Design Brief

6310 Hazeldean Rd. Development

December 2023

Review of UDRP's comments received on October 6th, 2022

CONCEPT SITE PLAN - PROPOSED IN FALL 2022

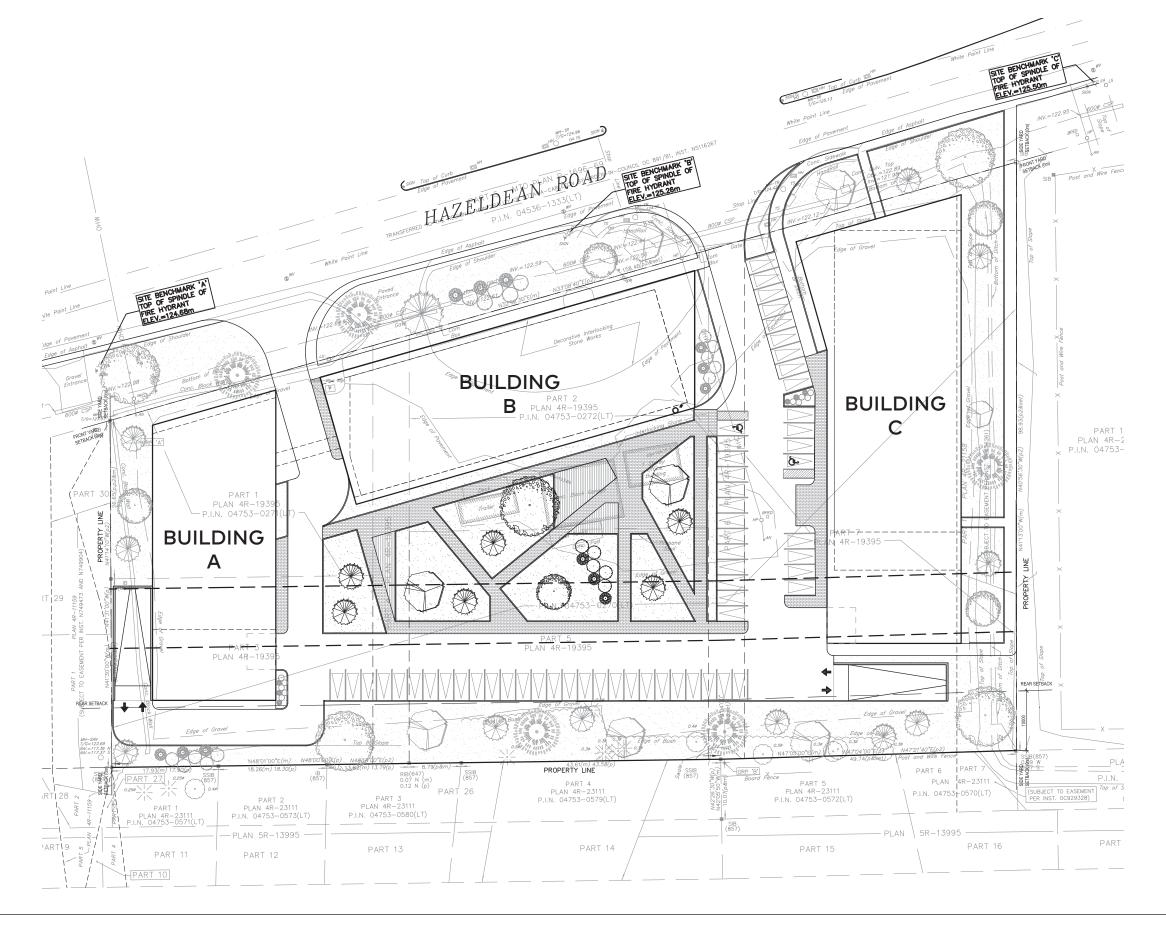
The Panel believes that the site will set a precedent in the area where a strong architectural expression and public realm vision is needed to embed the site into the greater landscape and neighbourhood context.

The Panel supports, in principle, more density on the site; however, there are more opportunities to enhance the public realm and landscaping and to build a sense of community while considering how the proposal will set a standard for the future.

At this stage of the development process, the Panel expects to see a proposal where the architecture has been resolved, is viable, will be built and become part of the neighbourhood. A more detailed proposal would enable the Panel to provide more wholesome comments and input.

The Panel expressed disappointment with the current level of resolution of the architecture.

The Panel recommends the City not grant the changes to the setbacks as the site provides enough space to accommodate the buildings while maintaining the setbacks requirements.

The Panel recommends increasing the density on Hazeldean Road and reorienting Building B to parallel the street to create an urbanized corridor. Should the building be parallel to the street, the Panel recommends connecting Buildings A and B with glazed volume. Additionally, the proponent should consider elongating the building to eliminate the north-south wing since the inside corner units of an L-shaped building have with limited access to light.

The proponent should consider relocating the drop-off area underground on the north side of Building C to provide access to all three buildings. This would open up the layby space and allow for more greenery and reconfiguration of the parking layout.

The Panel questioned the appropriateness and amount of commercial space on the ground floor, given retail may not be viable. The space could be used for residential amenities.

The Panel believes the site's configuration is dominated by parking. The proponent should develop a strong pedestrian realm proposal that accommodates bicycle parking and has a high-quality landscape with outdoor amenities and a residential character.

The Panel has concerns with the scale and massing on the site as the buildings do not reflect the neighbourhood's character and only relate to each other. The Panel recommends the proponent study the area and its architecture to establish a language that complements the neighbourhood.

The Panel notes the ground floors configurations are repeated throughout the site, and the suite plans might do not reflect the siting or architecture of the individual buildings. The proponent should consider providing a high-quality amenity at grade, as the amount of space allocated for each suite is questionable.

The proponent should consider more variety on the facades and larger glazed openings and the introduction of large family units to break up the sameness of the buildings. The proponent should also consider adding more glazing with masonry at key corners to provide amination at the ground floor level.

The Panel believes Building C should have more articulation to break up the long façade.

The proponent should consider stepping and terracing the building toward the neighbourhood to provide a more significant transition and greenery at the rear

The Panel has concerns with the parking at the rear, given the possibility of headlights spilling into neighbours' yards. The parking does not allow for an outdoor amenity area due to the limited open space. The proponent should consider eliminating parking at the rear or designing the open spaces first, before laying out the parking.

There is an opportunity to add a bosque of trees and have a wrap-around landscape adjacent to the townhouses to create a strong landscape design and to strengthen the existing buffer.

The proponent should focus on site sustainability by implementing stormwater management and providing opportunities within the landscape to integrate utilities.

Acknowledged, a new updated concept has been prepared that includes a strong contemporary architectural expression. This new proposal includes a stronger ground plane experience with ground floor accessible units and strong active entrances for the two buildings proposed.

Agree, the new concept provides a stronger presence to Hazeldean while providing a strong transition to the neighbouring properties to the south. Though a future ROW is considered in the site plan placement of the buildings, we anticipated that this new street scape will eventually include for stronger pedestrian sidewalks, a bike path and significant green space that is included in this proposal.

Acknowledged, the team has included Figurr Architects who have prepared a more detailed exploration of the development, including enhanced urban design experiences, building massings and aesthetics, as well as how the buildings reflect the existing urban conditions along Hazeldean Rd. and the neighbouring properties.

Acknowledged, responded to in previous comment

Acknowledged, the site planning in the new proposal respects all required setbacks.

Acknowledged, a new proposal by Figurr Architects new proposes a two building solution with a strong street face along Hazeldean. Massings and heights have been carefully developed to contribute to a strong main street façade, an appropriate transition to neighboring properties, as well as considering sun and shading of the massing against this and other neighboring sites.

Acknowledged, a new two building proposal has been prepared with a stronger centralized drop off for both buildings under building 1. Parking has now been concentrated within a two storey parkade structure (and u/g garage) that has been clad with light coloured panels and vegetated screens.

Acknowledged, commercial no longer part of new updated proposal.

Acknowledged, at grade parking has been greatly minimized to provide mostly for visitors. A new 2 storey parkade (and u/g garage) will house remaining parking. A large amenity terrace will be located above the garage parkade.

Acknowledged, this new proposal has a stronger contemporary language. This area of the city does NOT have a specific and strong existing building language. The area is dominated by a mix match of suburban single family homes, industrial lands and typical suburban commercial strip centres. We do not believe that these are great examples to draw from and believe that the new concept – through thoughtful massing, proper transitions, and enhanced green buffer areas - provides a strong refined aesthetic that actually responds to enhancing urban planes.

Acknowledged, the new proposal has been properly explored to include proper ground floor programming for these types of buildings. Programs have been located to enhance the public realm with clean open and active entrances and amenity areas along Hazeldean. Bike rooms, move-in rooms and access to other supportive programs have been properly located to further support the concept.

Acknowledged, the concept attempts to address these concerns with a strong contemporary design as also previously mentioned in past comments. Larger units will be part of the project but a final unit typology will be part of a future Site Plan Control submission.

Acknowledged, please see new proposed concept that has a two building solution with varying setbacks and material explorations.

Acknowledged, new concept has been primarily developed by exploring that major aspect along the neighbouring properties.

Acknowledged, a new enclosed parking structure integrated with the buildings has been proposed. This greatly reduces the at grade parking. Project will ensure a minimum fence line and significant 10m green buffer zone between the rear lot lines and any building or parking area.

Acknowledged, please see new concept that greatly increases the use of green landscaping and significant buffer zones.

Acknowledged, as the concept now evolves, this will be part of the proposed project.
